Creekside, Preliminary Plan No. 120160130 and Site Plan No. 820160050

Staff Report Date: 3/21/16

Description

Figure 5: Variance Tree Locations

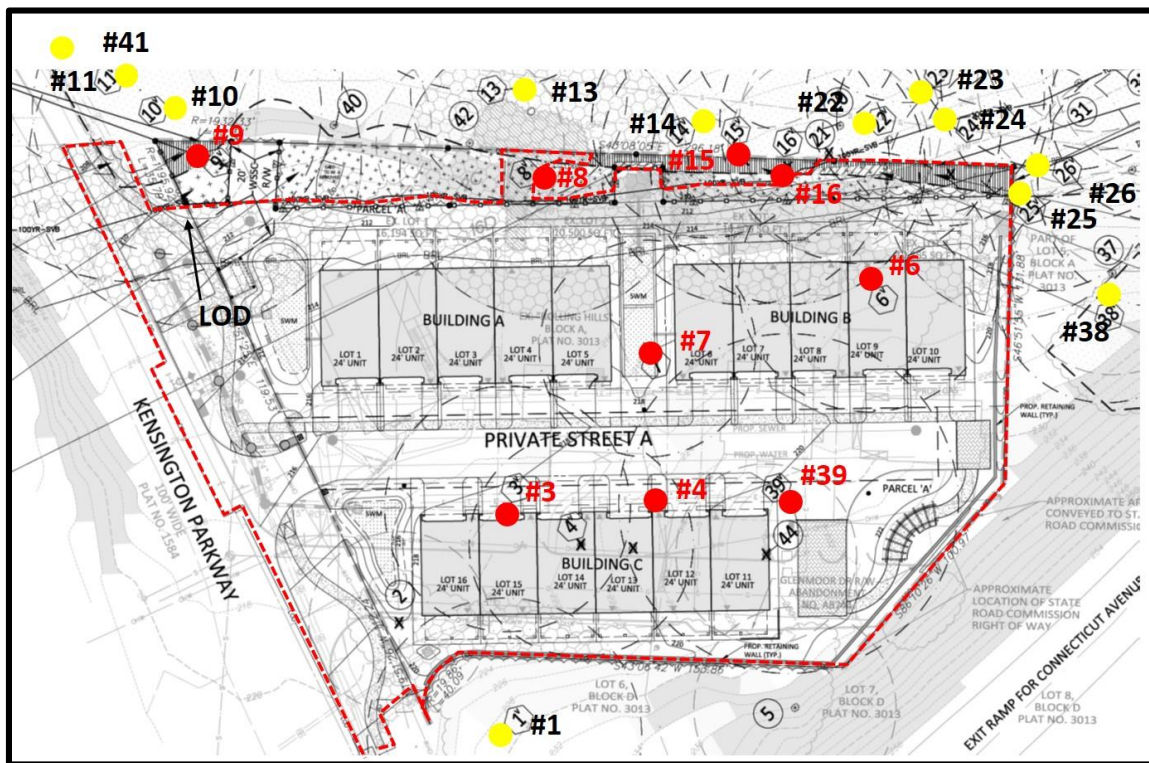
The Applicant submitted a variance request on 12/2/2015 and revised variance requests on 1/28/2016 and 2/16/2016 for the impacts to trees (Attachment 7). The proposed layout will remove nine trees and impact, but not remove, 12 trees that are considered high priority for retention under Section 22A-12 (b) (3) of the County Forest Conservation Law.

The Applicant is requesting a variance to remove nine trees. The nine trees (listed in the removal table in figure 5) will be mitigated at a rate of 1" caliper per 4" DBH removed, using a minimum 3" caliper native shade tree. The Applicant will plant 26, 3-inch caliper trees and two 4-inch caliper trees, which are shown on the Final Forest Conservation Plan.

The Applicant will plant 26 3" caliper and two 4" caliper native shade trees to replace the form and function of the variance trees proposed for removal. The proposed plan also allows for the reforestation of the floodplain on the northern property line. In addition, the Site will be developed in accordance with the Maryland Department of the Environment criteria for stormwater management, including the provision of Environmental Site Design to protect natural resources to the maximum extent practicable.

FIGURE 10: 2040 35 FOOT NOISE CONTOURS

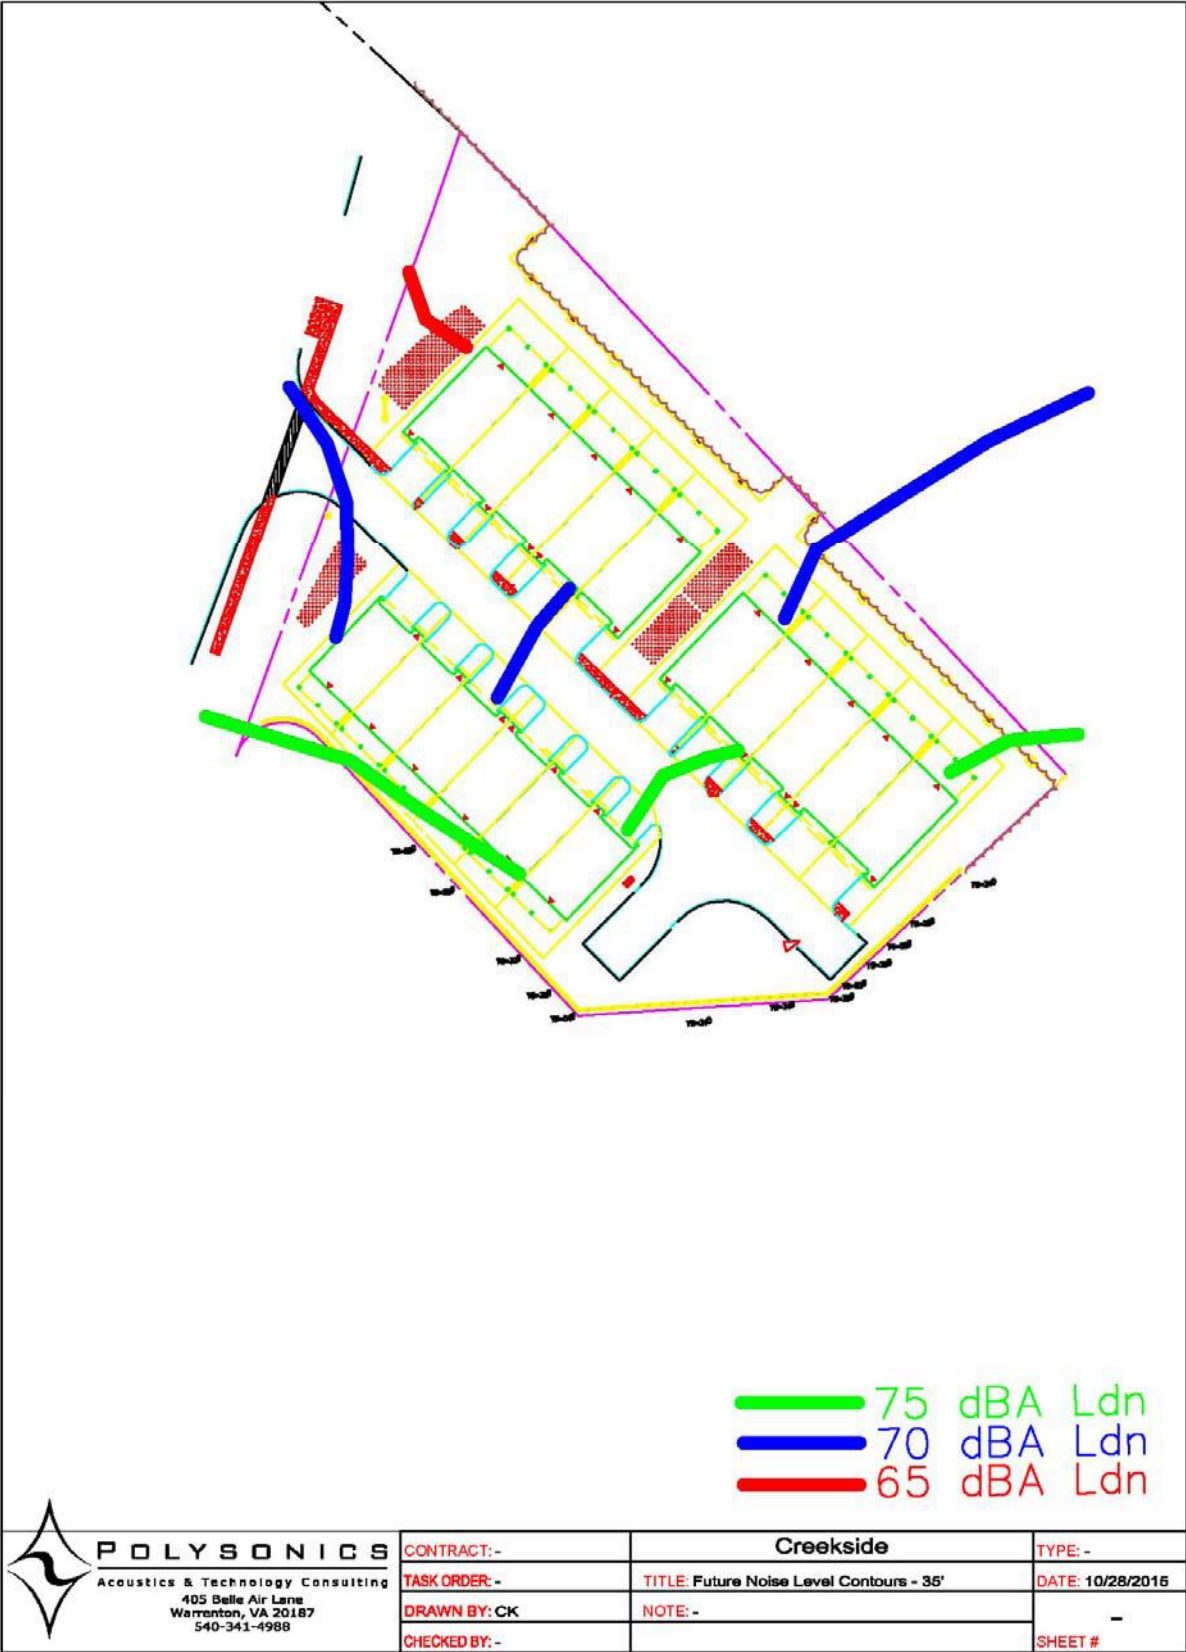
Any house impacted by the 65 dBA L_{dn} noise contour will require building shell modifications. As can be seen in Figure 10, this includes all of the buildings. Enhanced building materials (such as modified windows, doors, and wall construction) will be necessary for the residences.

FIGURE 11: BARRIER LOCATION

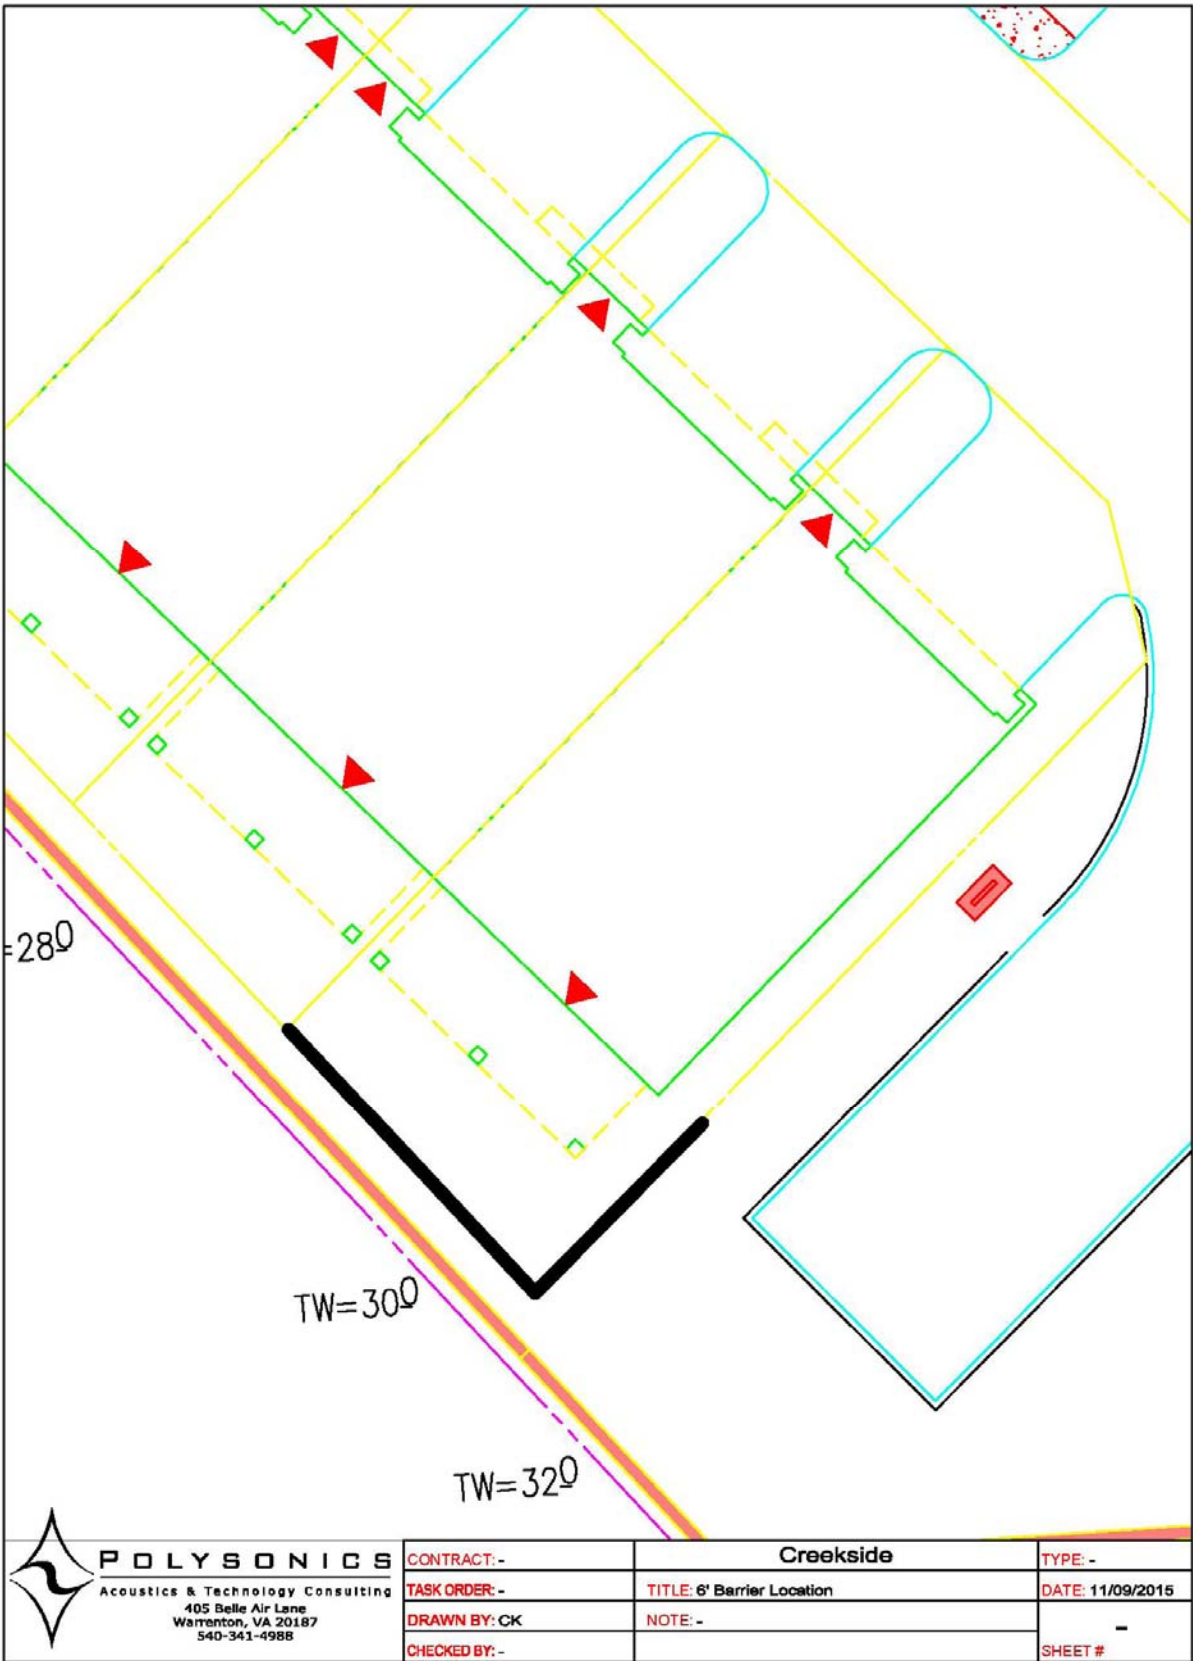
As can be seen in Figure 8, the future ground level 65 dBA L_{dn} contour can be seen impacting the rear yard of Lot 11.

Polysonics proposed a 6-foot high solid wood fence placed along the rear of Lot 11. The barrier location and elevations can be seen in Figure 11.

- d. The Applicant must disclose in writing to all prospective purchasers that the units are impacted by transportation noise.
 - e. Prior to completion of the Lot 11 townhouse, a 6-foot high noise barrier as shown on the site plan must be constructed along the rear yard of Lot 11.

FIGURE 12: BARRIER DETAIL

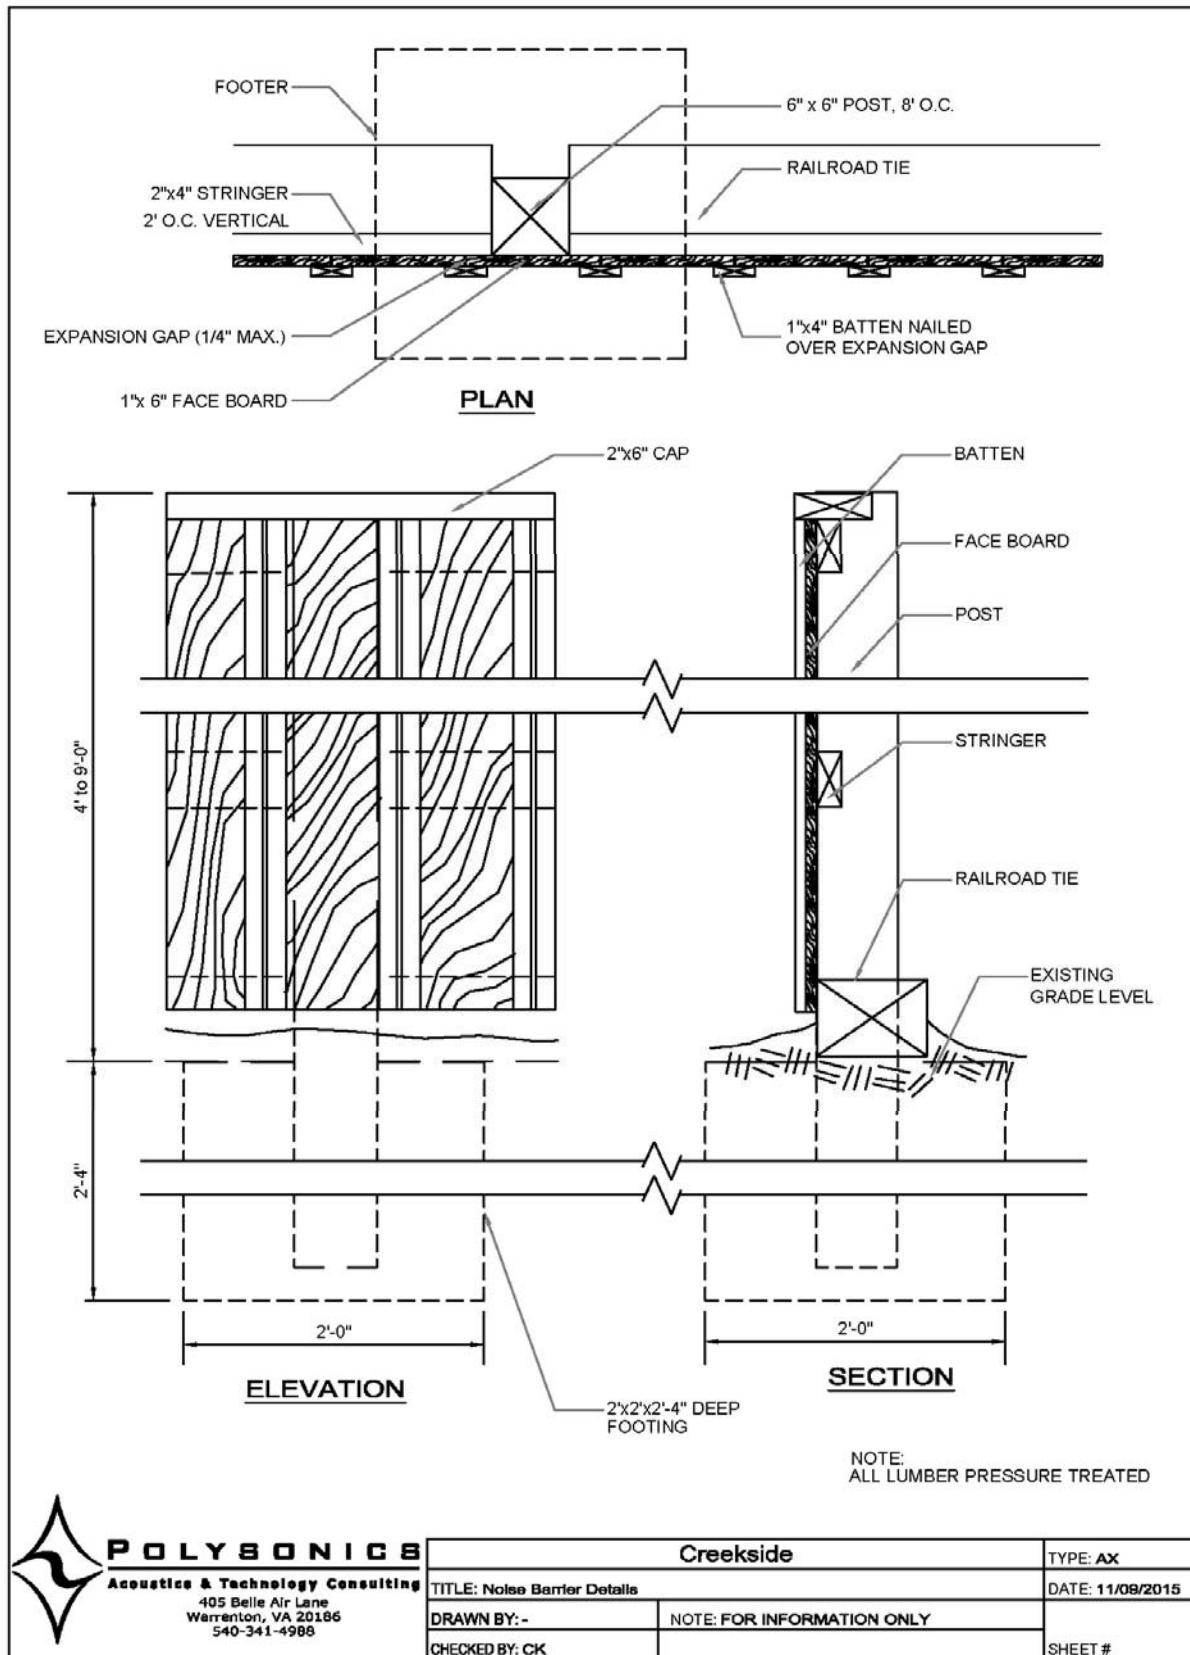
Since the noise levels need to be reduced by at most 3 dB, a wood fence will suffice. Per the HUD Noise Guidebook, the barrier needs to have at least a 13 dB reduction (or STC 13) to effectively reduce noise levels at the site. A detail of a wood fence capable of meeting STC 13 can be seen in Figure 12.
